**RE : Responses to Peer Review Comments for Arkell Subdivision, South of Arkell
Road and East of Watson Road South, Puslinch, ON
HGC Project #: 02600117**

As requested, please see HGC Noise Vibration Acoustics responses to the Peer Review comments from Valcoustics Canada Ltd. dated April 21, 2025. The comments are presented below, and our responses follow in *italics*.

Figure 2: Proposed Concept Plan Showing Prediction Locations

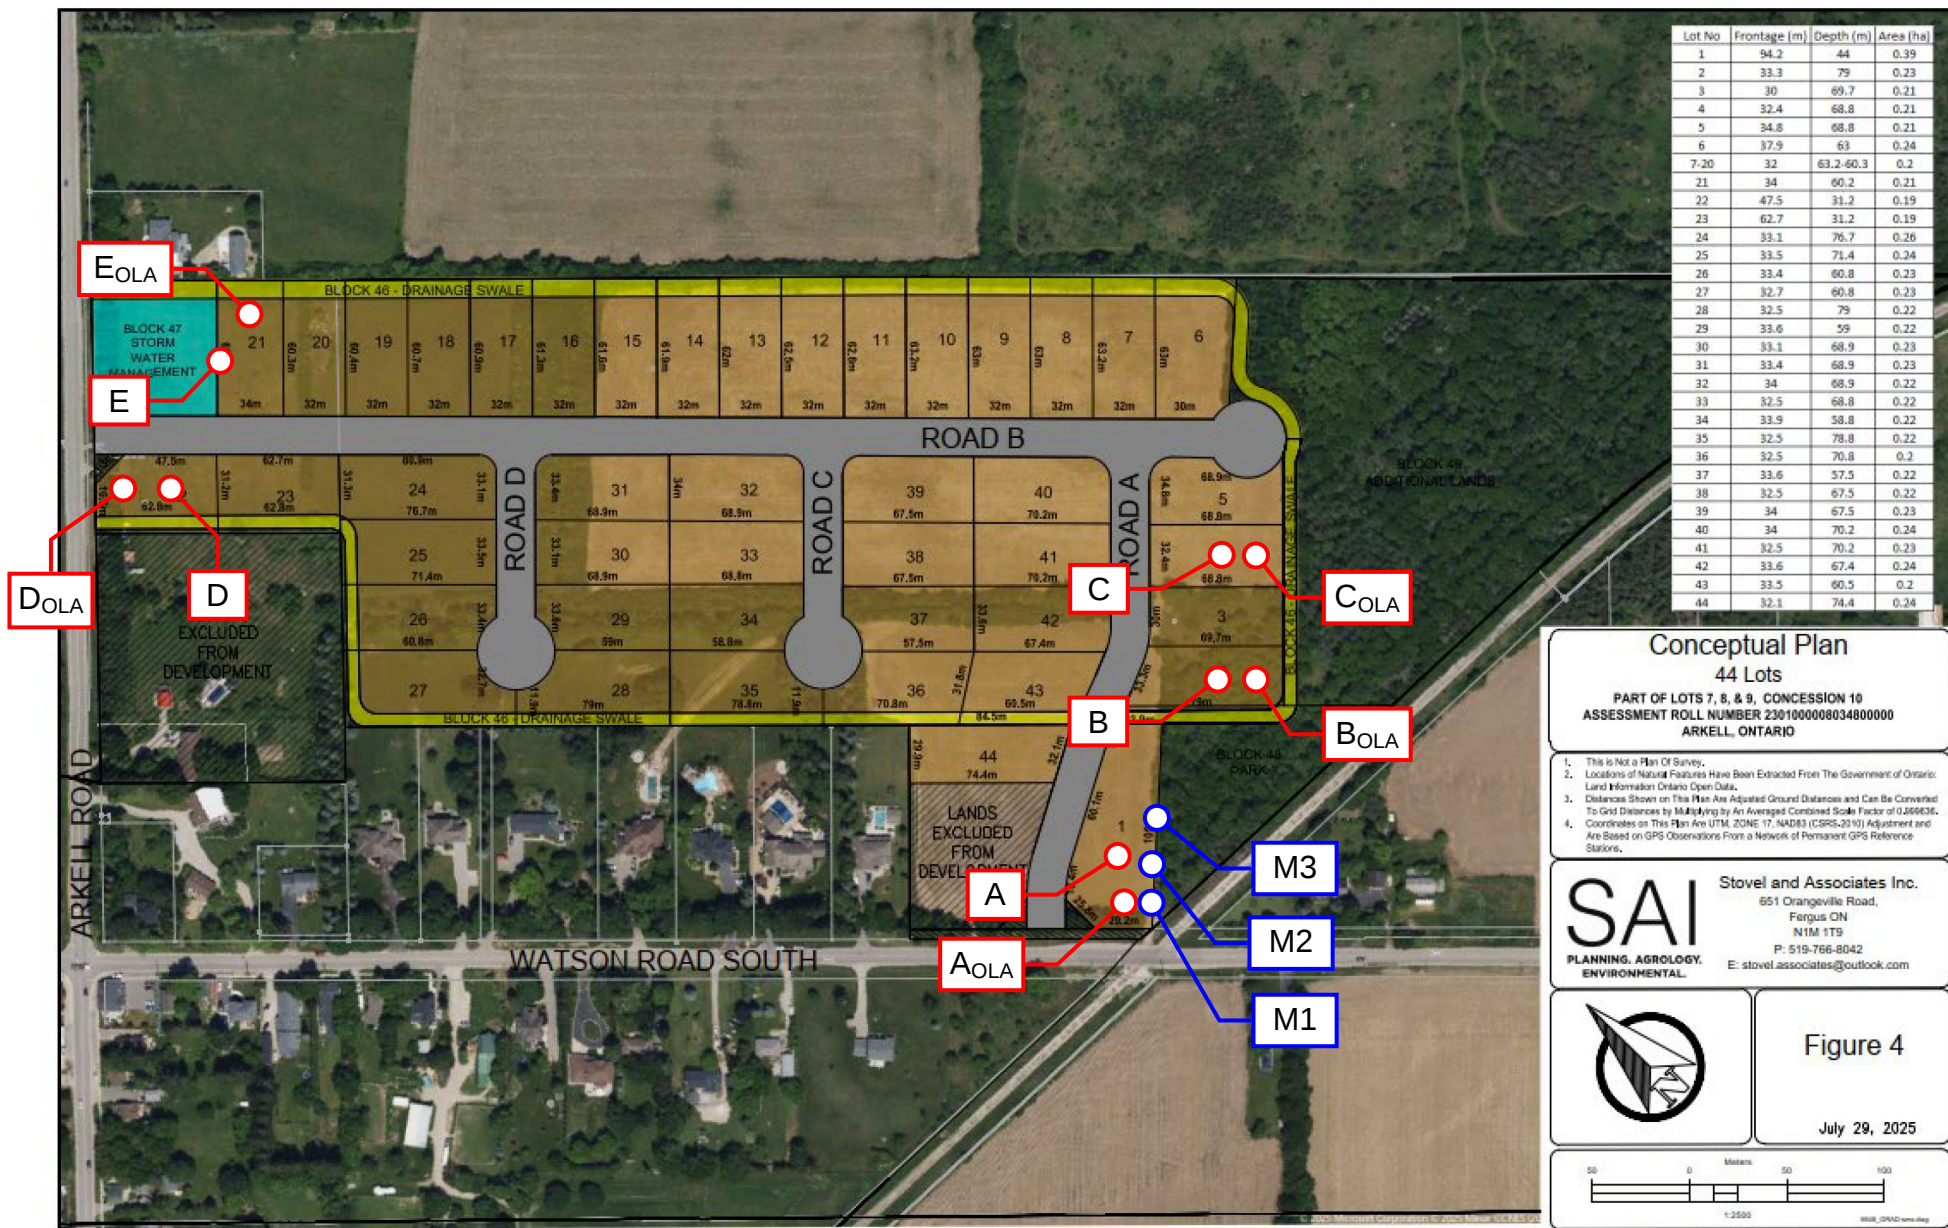
- d. The future sound levels at Prediction Location D presented in Table 4 assumes the dwelling is located to the north of the OLA which maximizes the distance from Arkell Road. However, the Onsite Sewage Servicing Schematic shows the dwelling at the southern portion of the lot with the OLA to the north and fully exposed to Arkell Road. An updated assessment for this location is needed.

Figure 2 has been updated to reflect the more conservative location of the OLA adjacent to the roadway. If the OLA is 15 m from the centerline of the roadway, the predicted sound level will be 60 dBA.

As per NPC-300., the OLA should be assessed 3 m from the building façade. In this scenario, the predicted sound level will be less than 55 dBA and physical mitigation is not required.
